# Product Change Notification (PCN)

PCN Number	506187	Date Issued	September 27, 2018
Reason for Change	Change to Product		
Change Type Description	This letter is to inform you that changes are being made to the part(s) identified in this Notice. The change may affect the fit, form, function or appearance of the parts, or it may result in a change to the specification. The pictures below show an example of the possible differences.		
Reason for Short Notice	Corrective Actions		
Assessment of Change	Passed FAI		
Internal Molex Qualification Date	October 19, 2018		
Sample Availability Date (Changed Part)	October 19, 2018		
Planned Implementation Date	November 01, 2018		
Method of Identifying Change	Date code

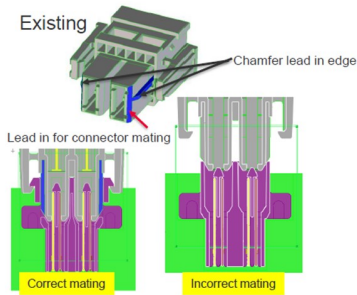
- As a valued customer, we wanted to notify you of a change in a fool proof feature on crimp receptacle housing, where the chamfer edge is removed and a flat edge is introduced to prevent wrong orientation when mating with plug.
- Product Impact
  - No impact to Form, Fit, Function nor Packaging
- Part Number Impact
  - Refer to attached Part No List
- Qualification Reports and samples available upon request after the date shown above
